Re: Supplemental Limited On-Site Remedial Investigation Work Plan:
Phase 2, Revision 3
Universal Waste Site – Site No. 633009
City of Utica, Oneida County

RE: Response to NYSDEC comments dated February 13, 2015
Revised Supplemental Limited On-Site Remedial Investigation Work Plan – Phase 2
Universal Waste Site – Registry No. 633009
Leland and Wurz Avenues, City of Utica, Oneida County

RE: Supplemental Limited On-Site Remedial Investigation Work Plan – Phase 2 (Revision 3)
Universal Waste Site – Registry No. 633009
Leland and Wurz Avenues, Utica, New York, Oneida County

FIGURE 5
DEBRIS PILE LOCATIONS

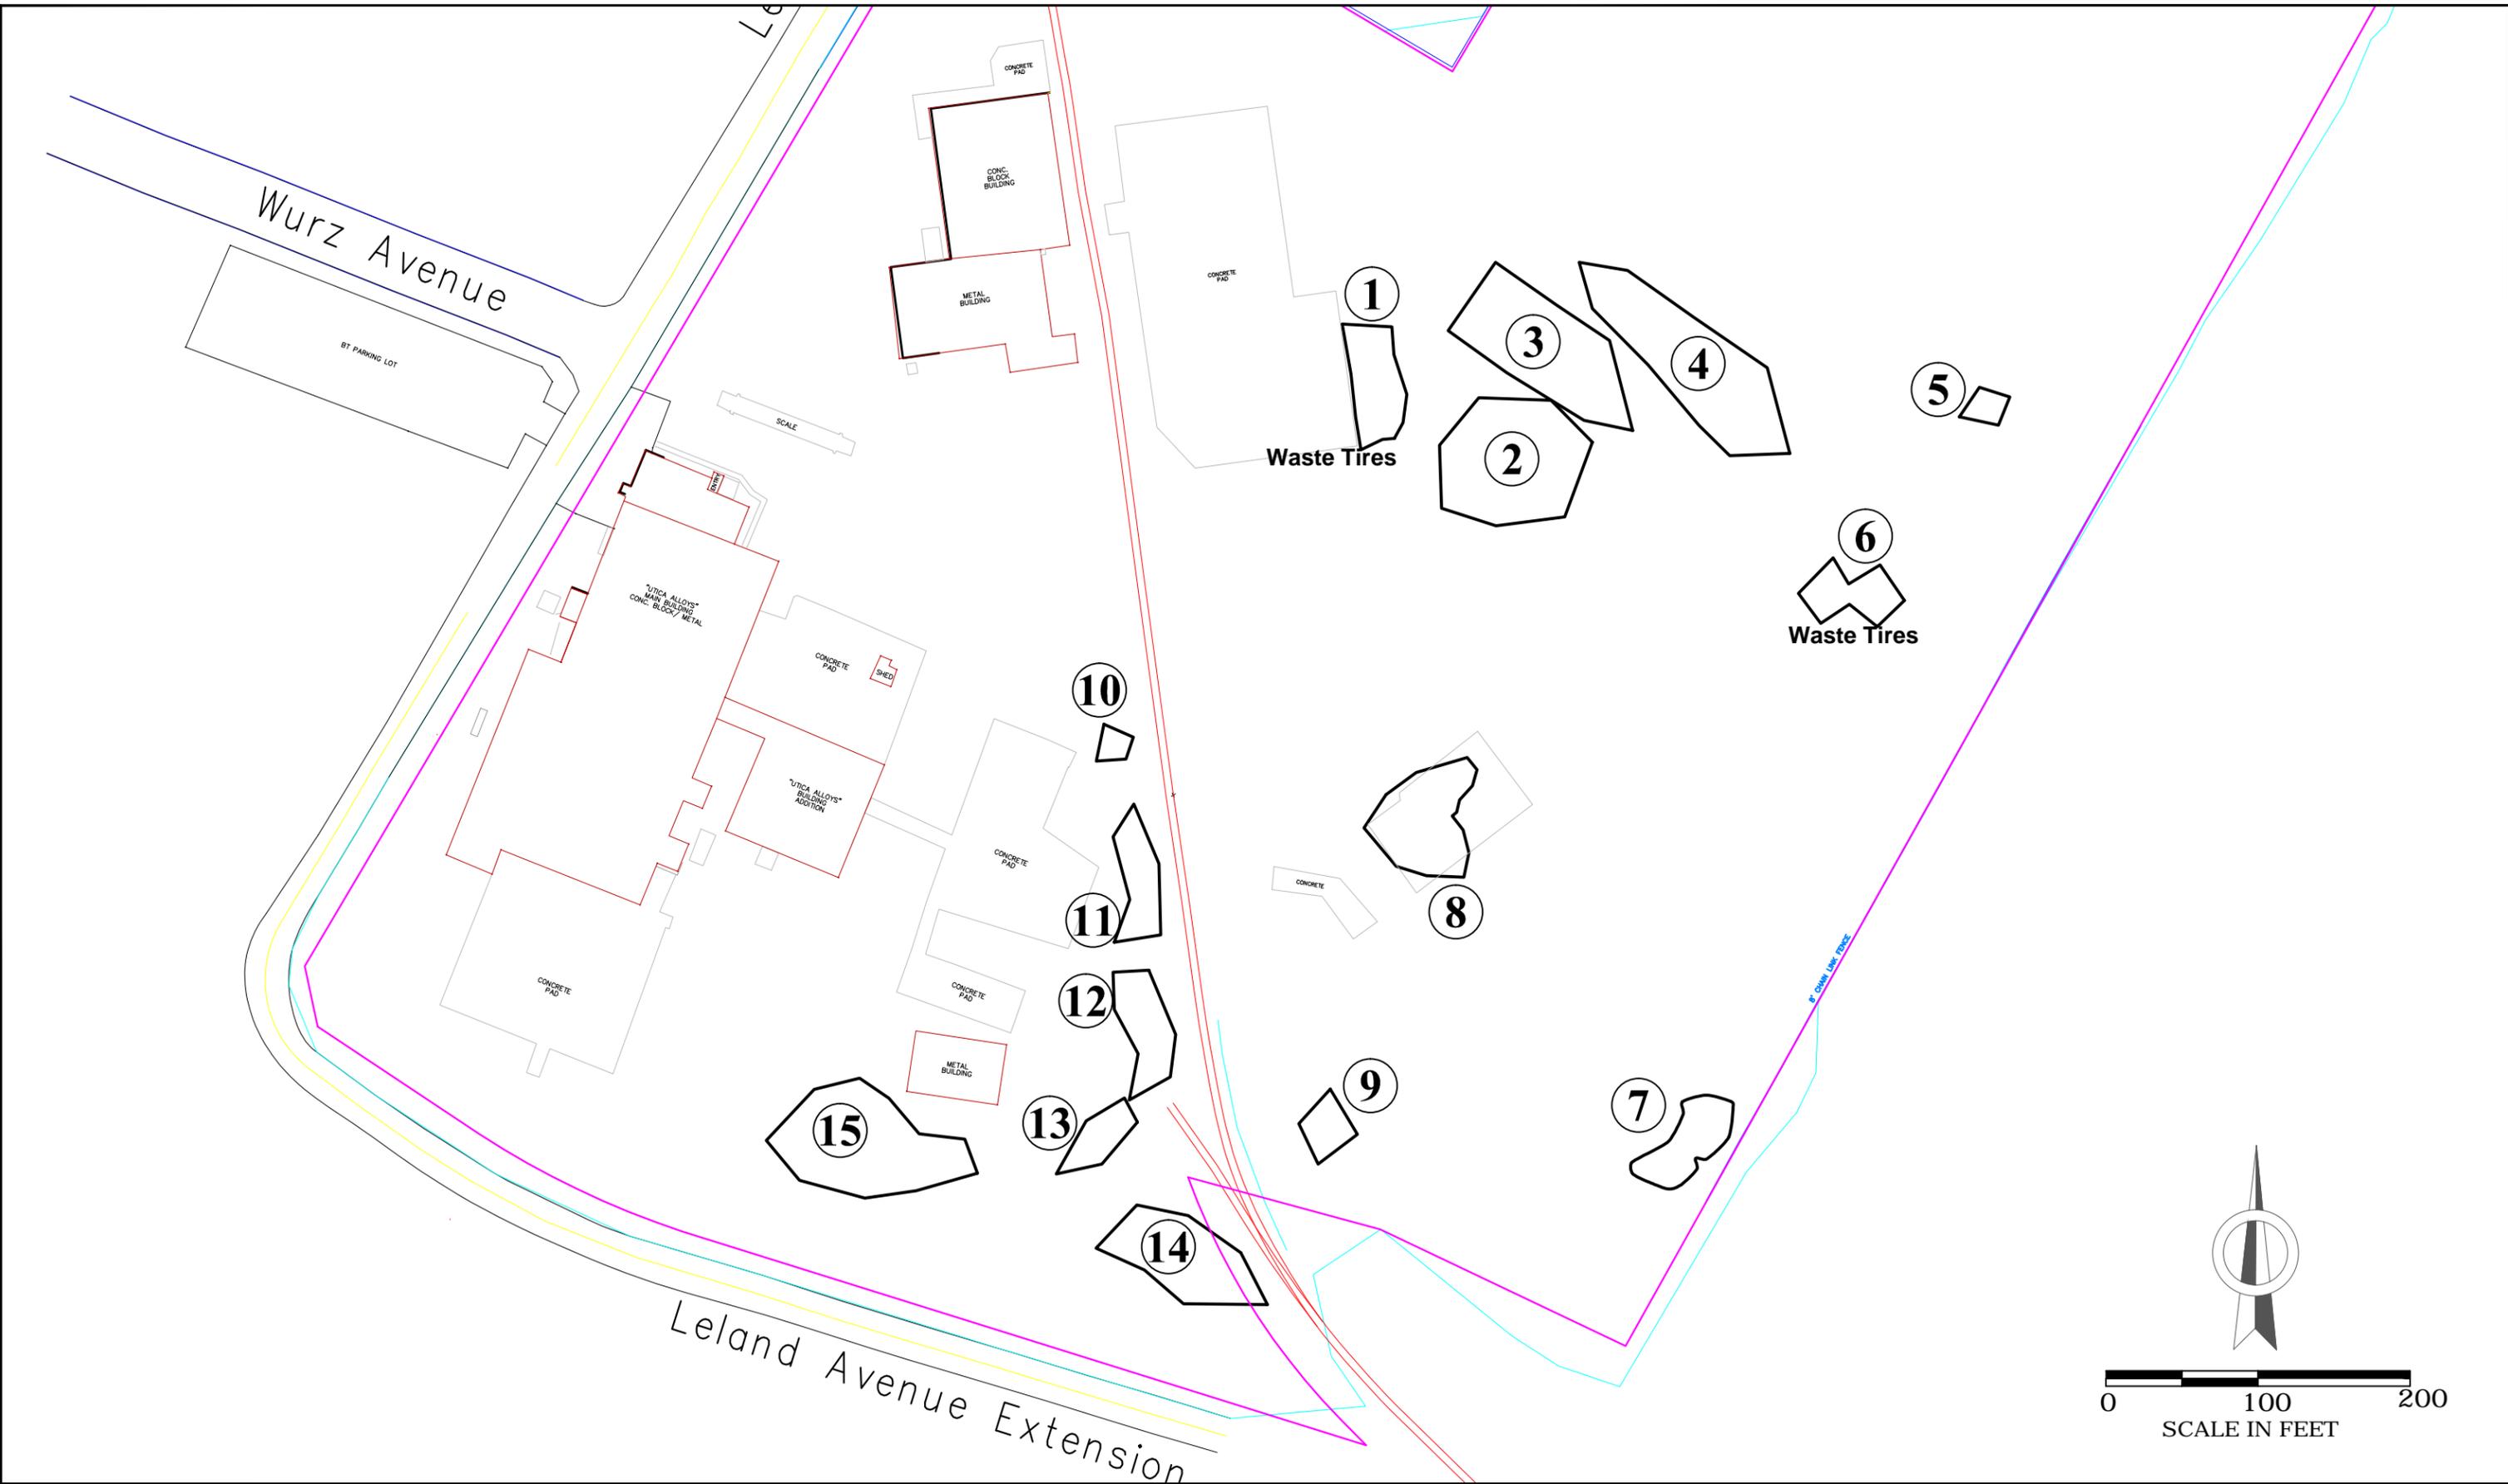
Please identify the piles containing waste tires.

Please include the description of the symbols used in the figure (Legends). Figure is too crowded. Please remove the contour lines. Just show pile boundary lines. Also identify the piles containing waste tires.

The locations of the piles containing waste tires have been identified on Figure 5.

The requested revisions have been made to Figure 5 of the revised Work Plan.

FIGURE 7

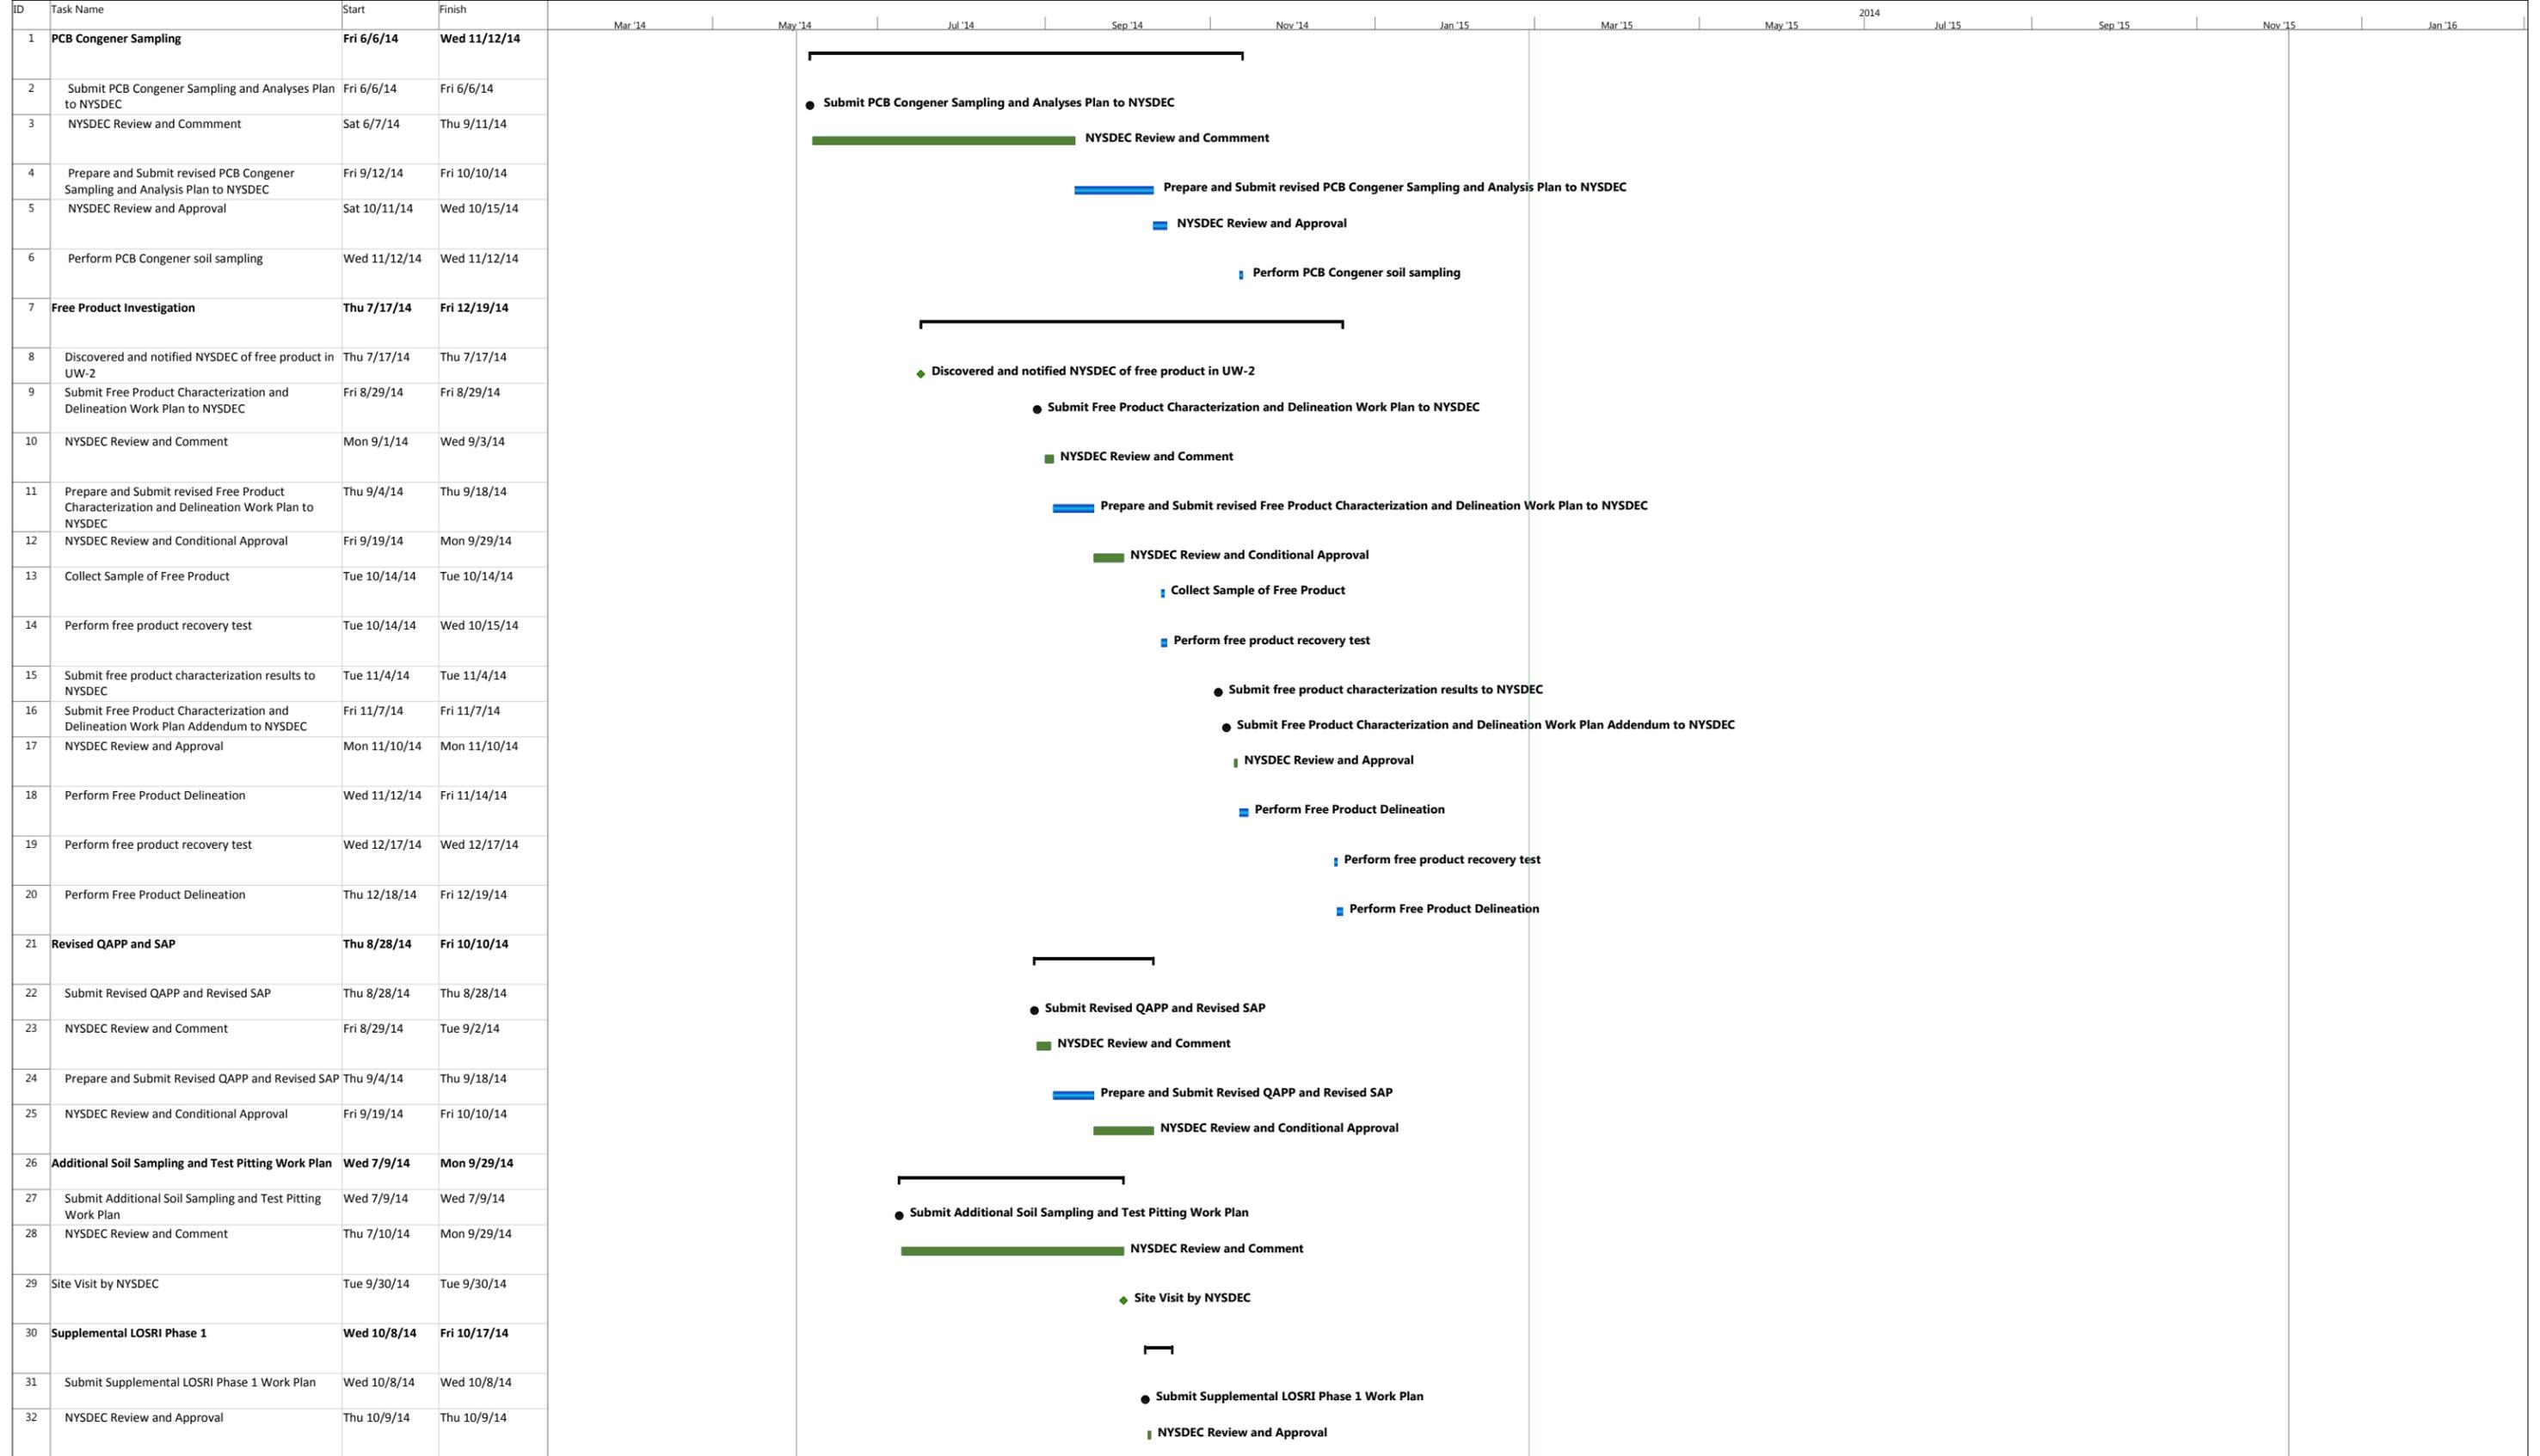
The Finish Date for Preparing and Submitting Final LOSRI Report (Task 63) mentioned in the Project Schedule (Figure 7) is modified to "10/2/2015".

The Department is unable to accept project schedule. It does not include all the elements and the tasks e.g. submission of reports, IRMs, task start date and actual or projected end dates etc. Also, to avoid confusion, it is preferable to update (by include additional/new task identified and updating start/end dates as the RI had progressed) the project schedule in the format approved in the original LOSRIWP (i.e. Gannet Chart). Please note that any changes/revisions to the project schedule needs Department's approval.

The schedule provided in the Work Plan was only intended to cover the tasks proposed specifically in the Work Plan. However, at the Department's request a comprehensive project is provided as Figure 7 of the revised Work Plan.
